TO: Design Advisory Board
FROM: Scott Gustin *SG*
DATE: April 12, 2016
RE: 16-0958SP, 316-322 Flynn Avenue

Request: Sketch plan review of project to remove deli building and residence and to replace with four story mixed use building with thirty apartments and two commercial spaces with associated parking lot.

PROPOSED SITE PLAN
scale 1" = 10'

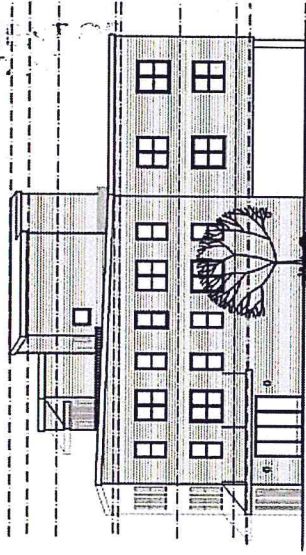
Reconstructed surface parking is placed to the side and underneath the building. The existing streetfront pavement will be removed and replaced with the new building and associated walkway and stairs. The building mass screens some of the parking from the street. Where the building is elevated above the parking, there is no screening. This criterion requires screening of this street-level parking with landscaping, public art, or other design amenities. Better yet, the parking could be more fully enclosed by the building.

Dimensionally, the parking spaces and back-up distances are smaller than the standard. Proposed parking spaces are just 18' deep, whereas 20' is the standard. Back-up length for the 90-degree parking spaces is just 20,' whereas the standard for such spaces is 24.' While some dimensional flexibility is allowed under the standards of Article 8, the applicant must demonstrate that the proposed layout will be functionally adequate. The sketch plans show no safe and unobstructed route, physically separated between vehicles and pedestrians, connecting pedestrians to the building entries or public sidewalk. Such route must be provided.

Exposed surface parking is limited enough (just 8 spaces) that shade trees are not required. Additional landscaping should be installed at the northwestern corner of the parking lot to provide screening from the street.

The sketch plans contain little in the way of landscaping details. Some lawn plantings are noted, and that is it. Permit application plans must contain more fully developed landscaping plans. As noted before, additional emphasis should be placed on screening the parking from the street. No new fencing is evident.

All utility lines must be buried. No ground-mounted mechanical equipment is included in the proposal. A trash and recycling enclosure will be provided at the northeast corner of the parking area. No enclosure details have been provided and must be included in the permit application. The dumpster must be set on a concrete pad.

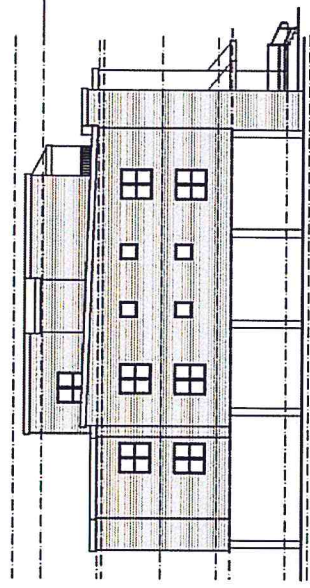
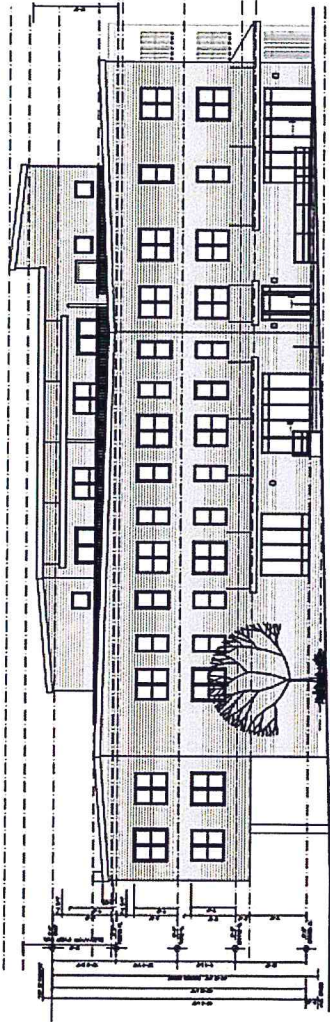
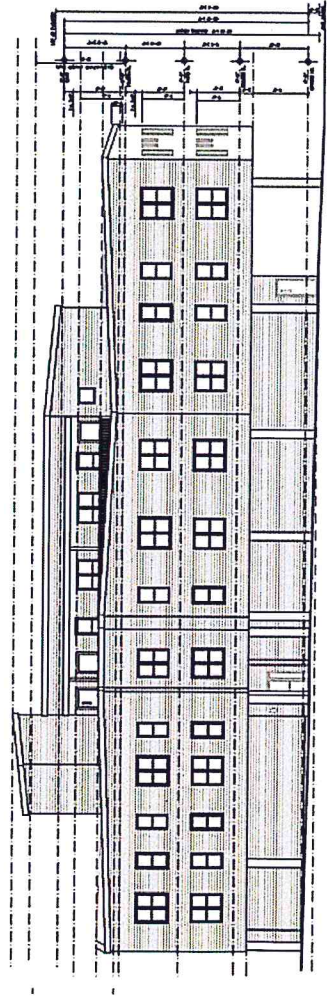
While the proposed building is significantly larger than that in the prior proposal, it is not out of context with other existing buildings in the area, particularly along Pine Street to the north. The proposed building is very similar in appearance to other recently constructed apartment buildings: boxy and angular with some variation in exterior color and building plane to break up perceived mass. There is no differentiation at the ground level except where the building is elevated on poles above the parking. Improvement is needed. While not an especially tall building, greater distinction is needed for the ground level – to strengthen its pedestrian interface and to separate it from the upper stories. More than half of the building is hoisted in the air on columns. While fundamentally this arrangement can work, its appearance from the street is awkward and contradictory to presenting an active and inviting face to the street. Ground level parking under the building is acceptable. The exterior building walls should be extended across most or all of the perimeter of the parking (of course leaving voids for garage entries). Instead of windows, grated openings could be used for ventilation. Doing so would provide greater continuity and strength to the building's ground level.

The proposed building exhibits two fenestration patterns, both of which are consistent with the overall appearance of the building. The ground level fenestration presents as that of a shop front while the upper stories incorporate a fenestration pattern more consistent with an apartment building. Fenestration throughout is appropriately scaled and suited to its intended purpose. The front entries are embellished with projecting awnings over the doorways.

As proposed, the building employs physical step-backs of its façade along Pine Street and Flynn Avenue to break up its perceived mass. The front entries are defined with shop front fenestration and awnings overhead. As noted above, there is relatively little that distinguishes the street level of this building from the upper stories. Greater street level detail is needed. This criterion spells out a number of options such as varying building materials, architectural features, and recessed entries.

No building materials are specified in the sketch plans, but the elevation drawings imply that the structure will be clad entirely in corrugated metal siding with metal coping along the roof edges. This material is acceptable for new construction; however, as noted above, a different material along the ground level should be used. Window, roofing, and awning materials are not noted. All exterior building materials must be specified in the permit application.
